Subject: Objective design review standards (Item 7-C on Historical Advisory Board’s 4-6-23 agenda and Item 5-A Planning Board’s 4-10-23 agenda) –AAPS comments.

2/22/21 ADOPTED OBJECTIVE DESIGN REVIEW STANDARDS

ADDITIONAL AAS COMMENTS -- 6/2/22

Illustrations by Teresa Ruiz

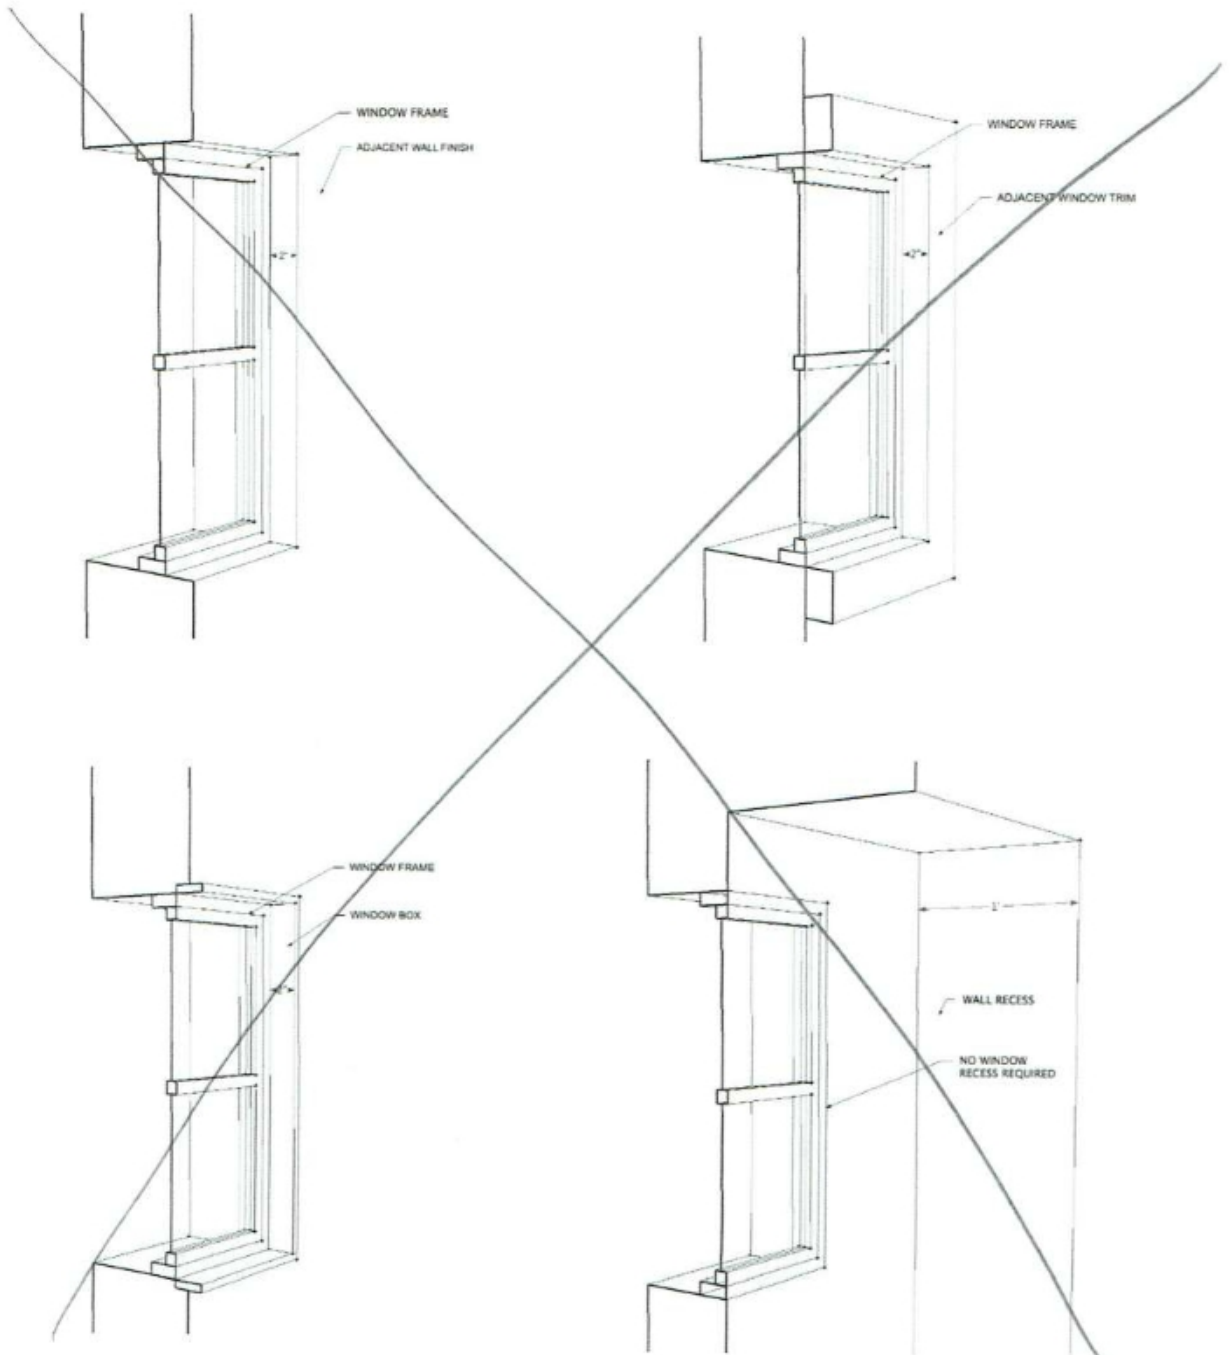
We have suggested modifications to the dimensions in the attached diagram to provide more flexibility. In addition to the changes shown on the diagram, the 3/8” recess of the glazing from the surrounding stiles and rails and for the thickness of any muntins as shown on the diagram should be changed to 5/16”.

Bottoms of windows shall have sills.

Attachment 2: Typical Dimensions of Wood and Steel Windows

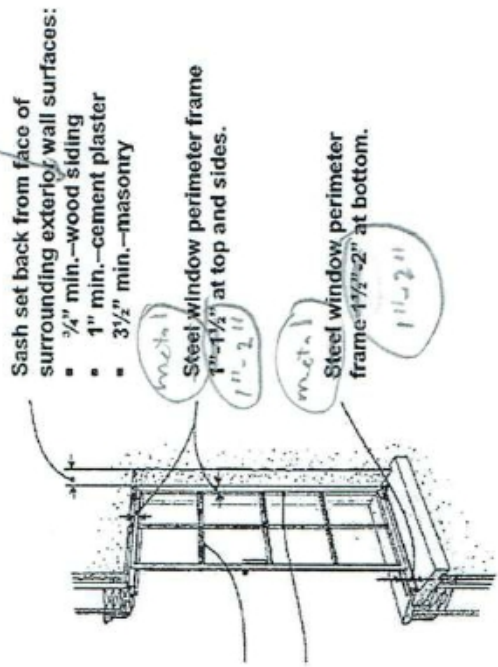
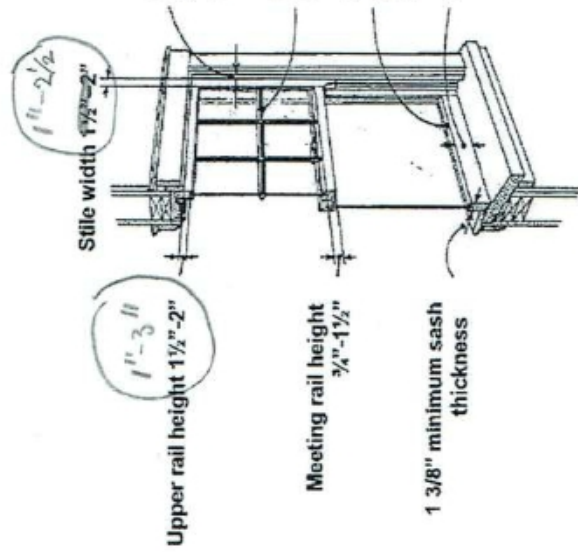
Window dimensions shall correspond to the typical dimensions of wood or (if consistent with the reference building's architectural style or the context buildings) metal as shown in Figure 1.

Individual windows within groups shall be separated by vertical trim or wall surfaces at least 6" wide

PROVIDE DEFINITION OF "VISUALLY MATCH" AS USED IN ALAMEDA PERMITS CODE IN THESE STANDARDS.
